Proposed Changes

FIRST PROPOSAL

Figure 4.4-3
Detail 1, Sheet D2

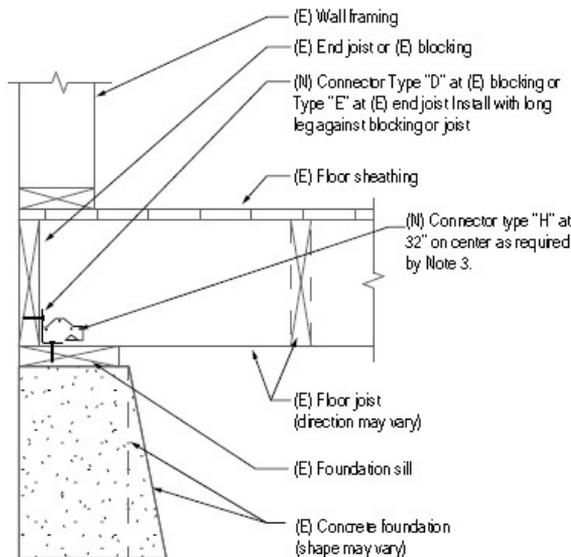
The L30 was chosen because it is only 3" long such that it can fit in narrow joist cavities as well as effectively make the connection found in the details where the Type H Connector is specified such as in Detail 1, Sheet D2.

The Type D,E, and H Connectors all have the same shape and this may confuse contractors.

Replace the Simpson L30 with the Simpson A23. It is shorter (2 3/4") than the L30 and has a higher capacity of 535#. This hardware is also easier to find at builder's supply stores. To my recollection this substitution was discussed and agreed upon at a cripple wall task group meeting.

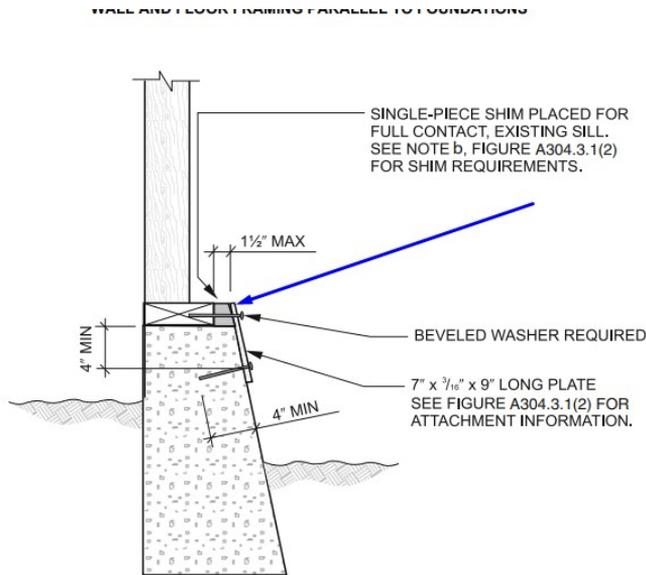
Notice how uncluttered and simple this table is to read. The entire table can be seen at the end of this report.

The Type B Connector only clutters the table, is never used, is a redundant piece of hardware and should be removed from The Standard.

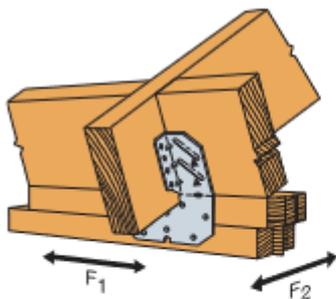
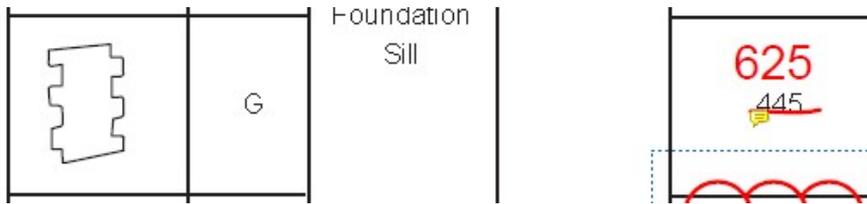
This appears to be the Simpson H10A. According to the current Simpson catalog it has a 565# value, not a 590# value.

Retrofit contractors almost exclusively use the H10AR because these old houses are made of full dimension lumber. The R stands for “Rough Cut”. The 590# comes from the Simpson Catalog listing for field bent H10As used on roof rafters.

Change the value in The Standard from 590# to 490# and change the quantities in the tables as required.

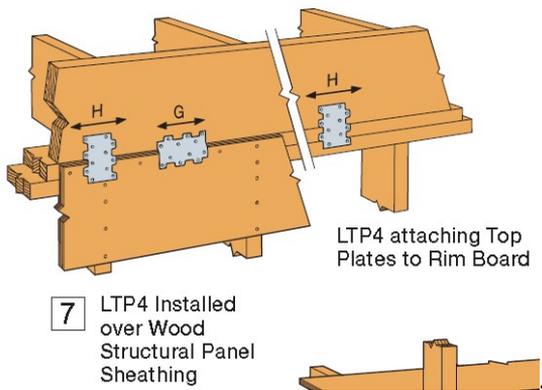
This is the Simpson LTP4 and has different values depending on the orientation and whether or not it is installed over plywood. According to the current catalog, the “G”: orientation is 715#, the “H” orientation is 525#.

The 625# value listed in Table 4.4-4 is not in the current catalog.

Change the value in Table 4.4-4 to the more conservative 525# value and change the quantities in the tables as required.

Figure 4.4-2 Detail 3

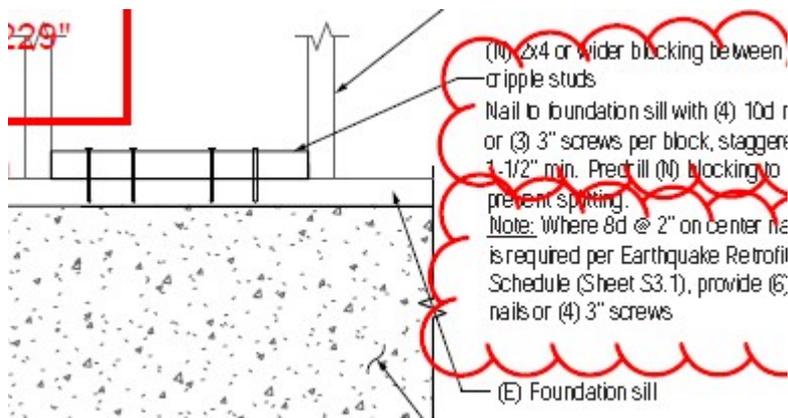
This block is required to provide a nailing surface for the plywood.

Add details for the Flush-cut Mudsill, Reverse block method, and the Stapled blocking methods.

Detail XX.

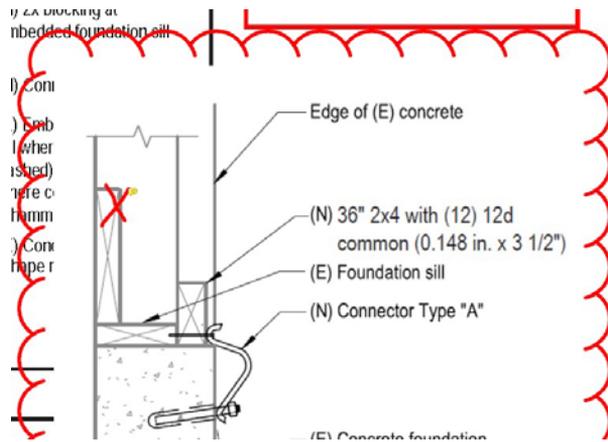
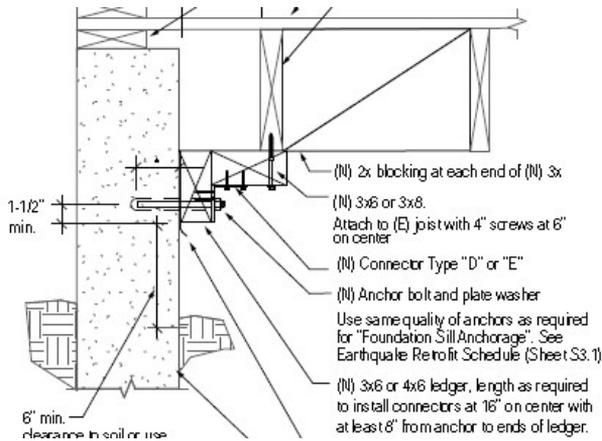
The block is touching concrete. To maintain consistency with the other details it might be a good idea to label this as pressure treated.

It may be better to connect the block to the sill with (5) 4 1/2" x 1/4" self tapping lag screws for a value of 2,000#. The specified screws are 3" long.

The cheapest alternative would be to have Simpson test this hardware without securing the block to the sill shear. This is how they tested the Type B Connector. In this case the only thing that would be required is a block and (5) longer 4 1/2" self tapping screws. T

Ask Simpson to test this hardware with an unsecured shear plane between the block and the sill as they did with the Type B Connector. Specify a pressure treated block. Secure all shear planes with the same fastener types i.e. 1/4" self tapping screws.

Detail 2, Sheet D2

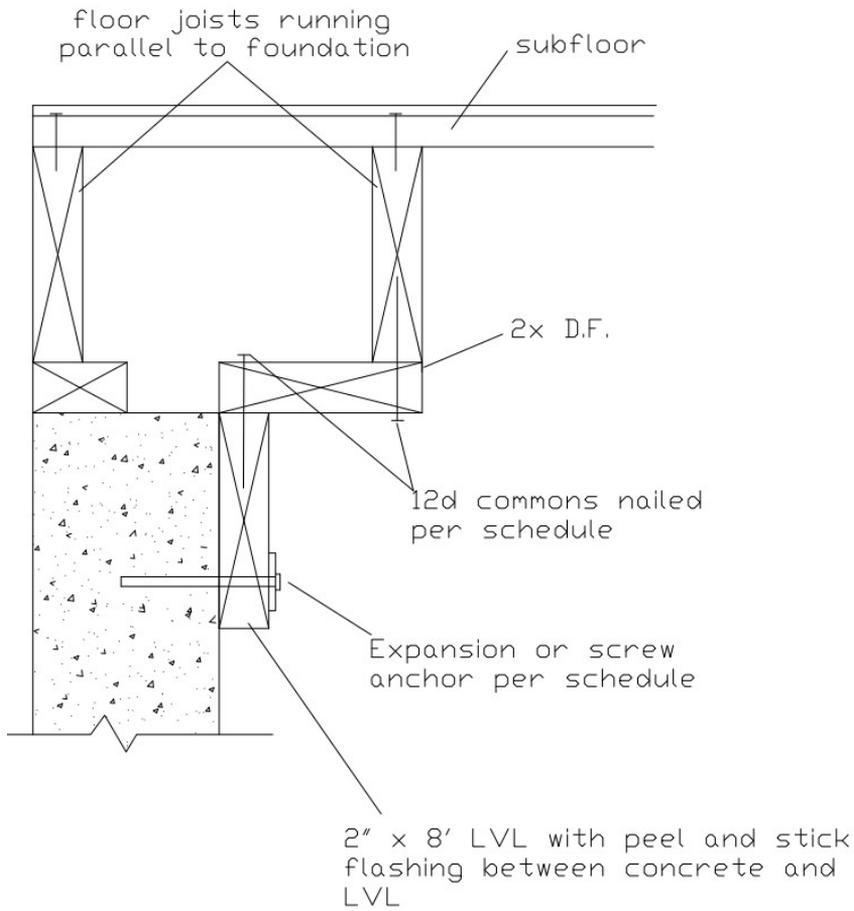
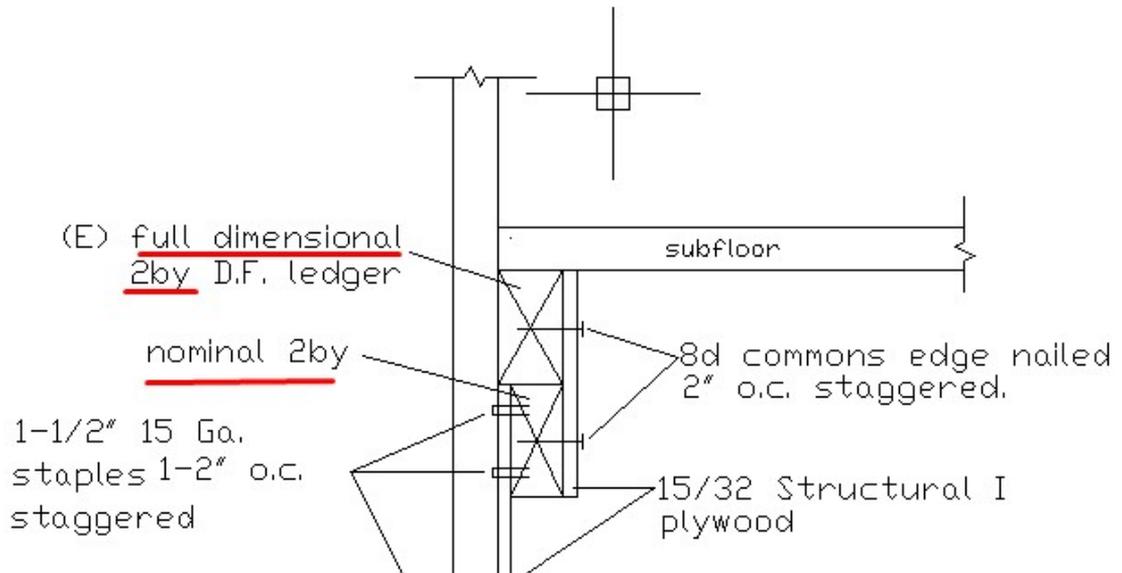
Why is 3x being specified here and in Detail 5 Sheet D2 and NOT in Detail 3-Sheet D2, Detail 4 Sheet D2, Detail 6 Sheet D2, Detail 3 Sheet D3, Detail 4 Sheet D3, Detail 5 Sheet D3, and Detail 6 Sheet D3?

This detail does the same thing and is used by many contractors. It is cheaper to install and just as effective.

Change the 3x lumber to 2x lumber in all the details.

Replace Detail 2, Sheet D2 with this one.

Detail 3, Sheet D2

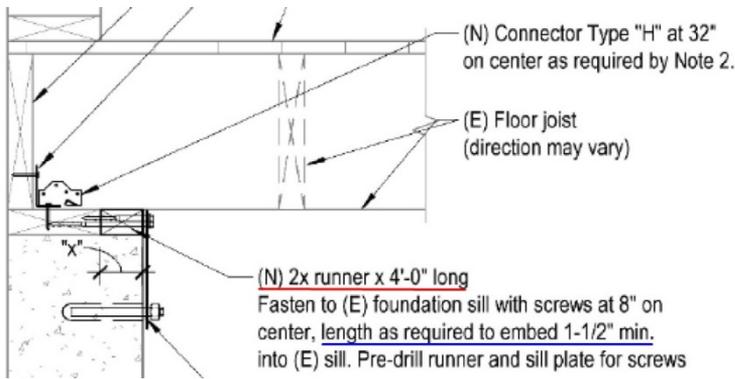
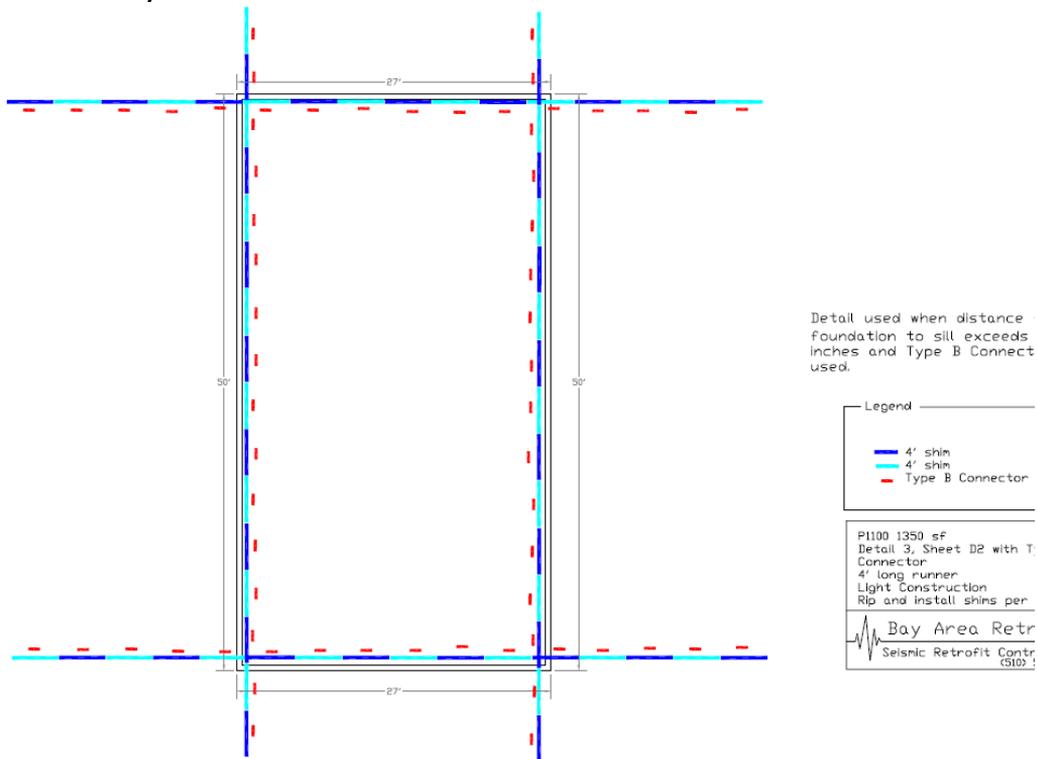
The shim is touching concrete. In order to make it consistent with the rest of The Standard it should probably be pressure treated.

The requirement that the screws be embedded into the sill 1 1/2" is not an approved embedment according to Simpson StrongTie who referred me to the table on the next page. The minimum penetration is 2".

When this detail is applied to a typical 27' by 50' single story house, the runners extend beyond the foundation.

Remove this detail. If it is kept change it to reflect the correct penetration and specify a pressure treated lumber runner.

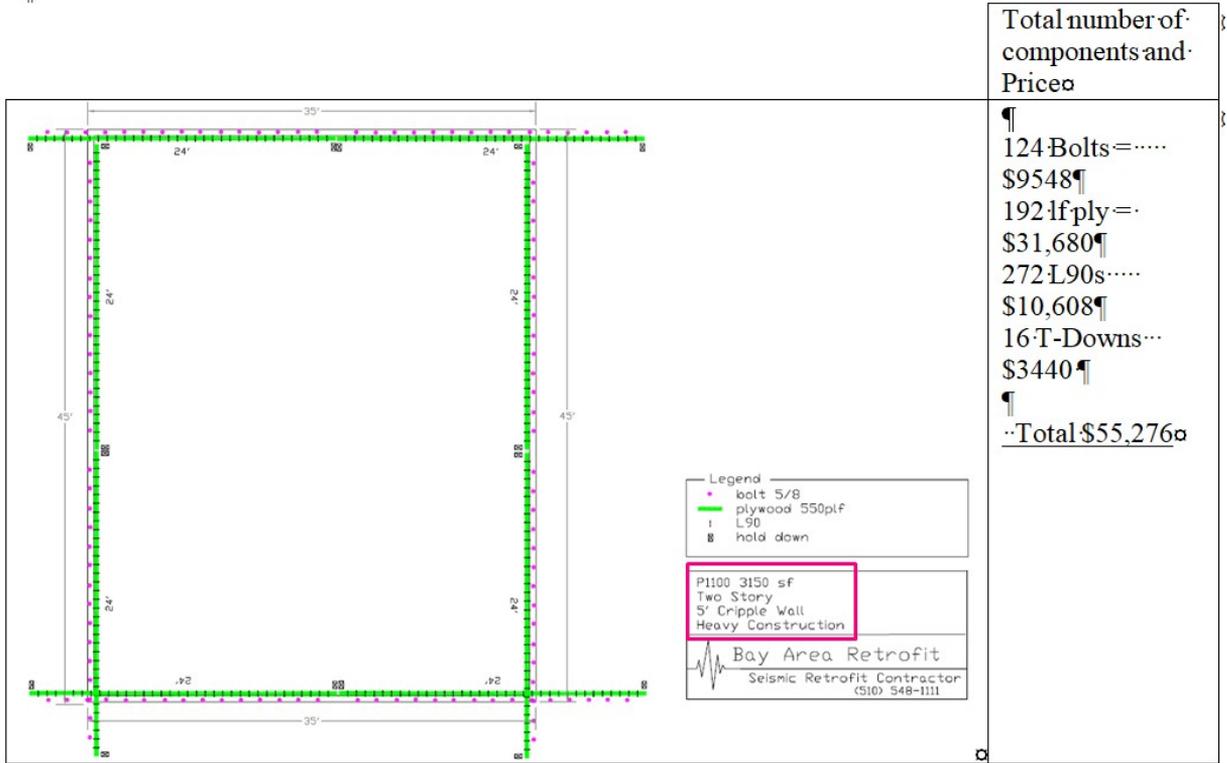
Installing the quantities in the table are not only costly, but can have seemingly absurd consequences where the retrofit runs out of foundation such as with this 2-story heavy construction house with cripple walls over 4'.

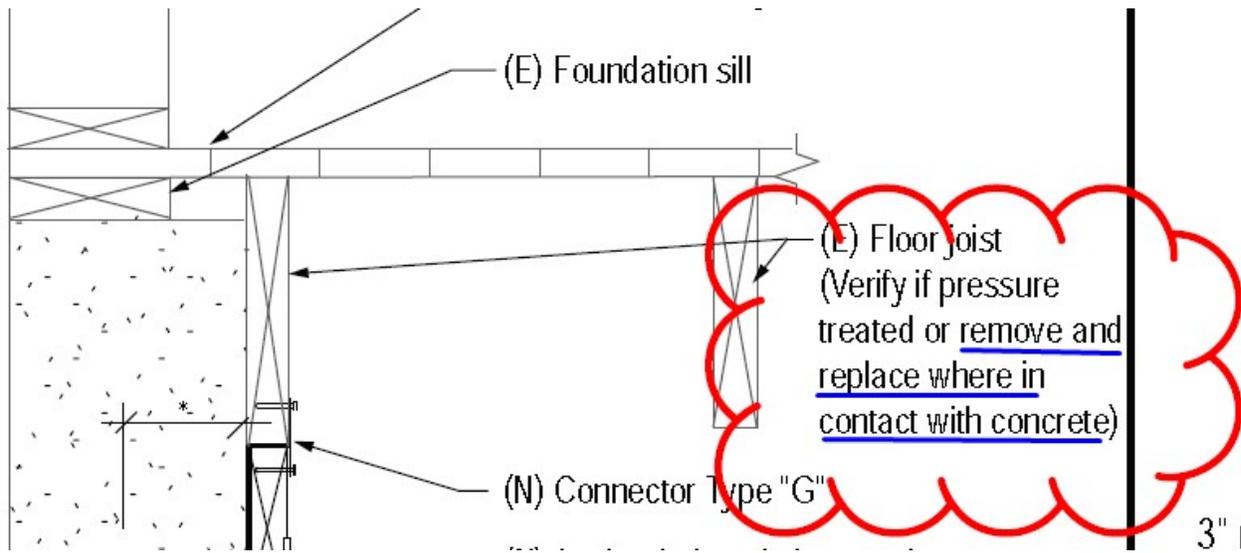
Some of the existing details are so contrary to a contractor's common sense that the other details, along with the entire standard, will be viewed with some suspicion. One example of this can be seen in Detail 4, Sheet D2 found on the next page.

In order to remove the floor joist, the nails connecting the subfloor to the joist must be cut out. This will break the load path from the sub-floor diaphragm to the joist. Replacing it with a new pressure treated floor joist does not restore the load path.

Add a booklet of additional details.
